Adamstown Station Block A, C & D

Stage 1 Road Safety Audit

Quintain Developments Ireland Ltd.

April 2022

Figure 2-1 - Dead end in Block A Car Park

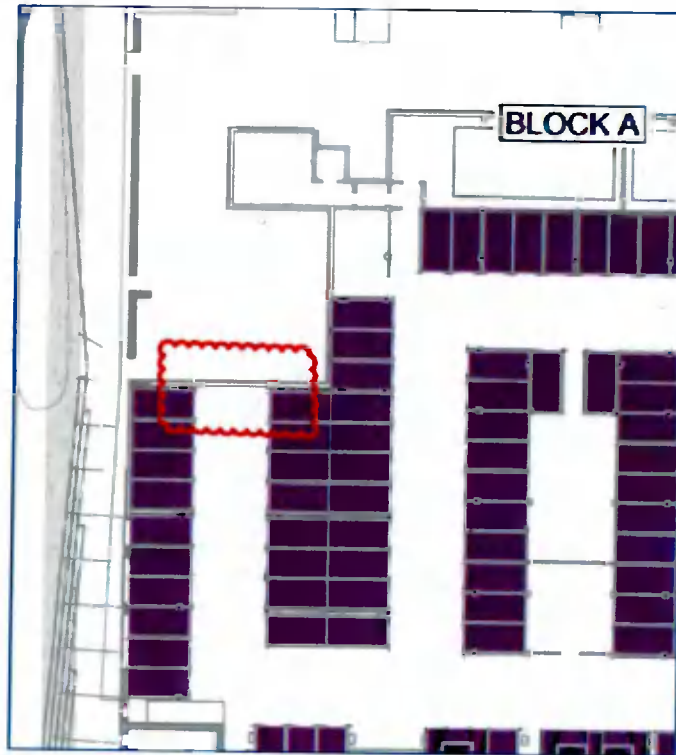
Location: Block A Car Parking

There is a dead end located in the block A car park as shown in Figure 2-1. Vehicles may find it hard to turn here if all the spaces have already been taken. Attempts to turn may cause rear end or front on collisions and conflict with pedestrian where drivers are required to reverse along the vehicle aisle.

The designer should assess the risk highlighted and provide a turning-head where this is found to be needed.

Figure 2-2 - Desire lines to cross West Street

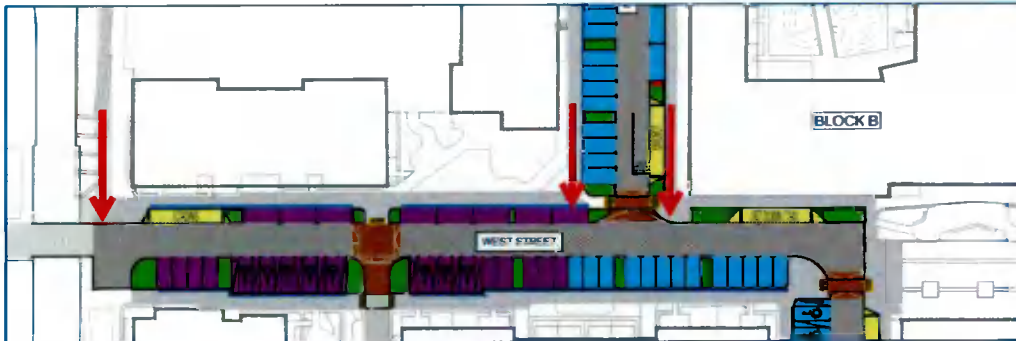
Location: West Street & Station Road

There are likely a number of desire lines located along West Street where pedestrians may wish to cross as shown in Figure 2-2 following. Crossing points have not been provided on West Street, this could lead to pedestrians trying to cross the road where it is unsafe to do so and possibly being struck by a vehicle.

A similar concern relates to the southern of the internal link between Block C and B. The signalised junction to the east appears remote and unlikely to be used by people who exit at this location.

The designer should provide a safe location for pedestrians to cross West Street and assess the need to provide Station Road noting the remoteness of the signalised junction.

Figure 2-4 - Controlled Pedestrian Crossing on Station Road

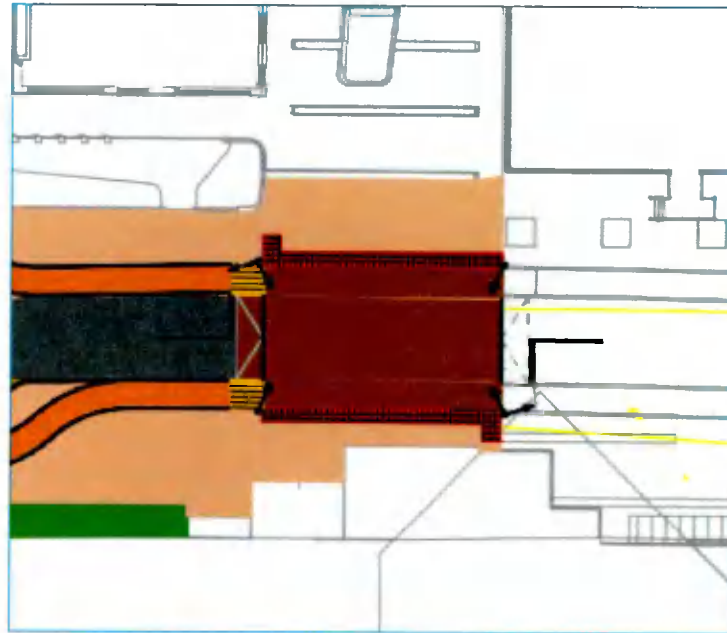
Location: Station Road

It is unclear if cyclists have to adhere to the traffic signals at the controlled pedestrian crossing on Station Road. The proposed ladder tactile paving suggests that cyclists are entering a shared area and do not need to adhere to the signals. This could cause cyclists to travel through the crossing on a red light and collide with a crossing pedestrian.

The designer should ensure it is clear that cyclists need to adhere to the proposed signalised crossing.

Figure 2-5 - Crossing for Bus Stop

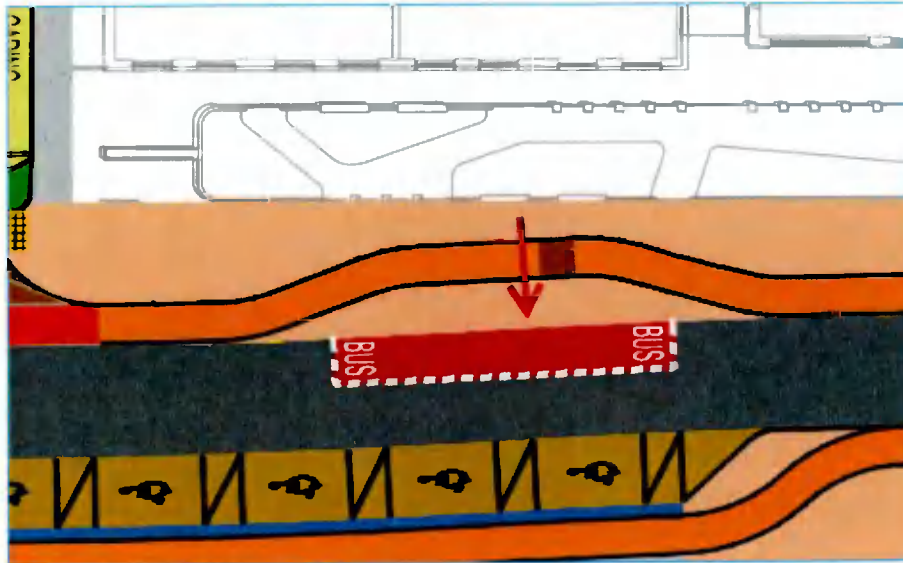
Location: Station Road Bus Stop

The proposed bus stop on station road requires pedestrians to cross over the cycle lane to reach the bus stop as shown in Figure 2-5. It is unclear who has right of way here and this could lead to a collision between cyclists and pedestrians trying to access/egress the bus stop.

The designer should ensure that it clear who has priority through this section.
